REMARKS

This amendment is responsive to the Office Action mailed October 16, 2003. For the following reasons, it is believed that the entire application is in form for allowance.

Serial No. 09/965,669

FIG 4

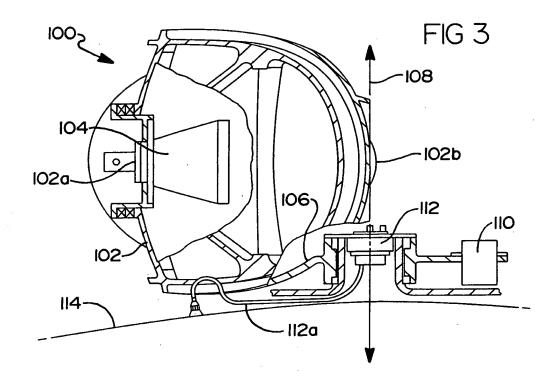
The Examiner objected to the drawings because of the use of reference numeral "102a" in Figure 4 was used twice to denote two separate portions of the antenna. In response thereto, a minor drawing correction has been made when one of the reference numerals "102a" has been deleted. The reference numeral "102b" denotes the outermost edge of the reflector 102. A corrected drawing sheet showing this change is also being submitted herewith. Reconsideration of this objection is therefore respectfully requested.
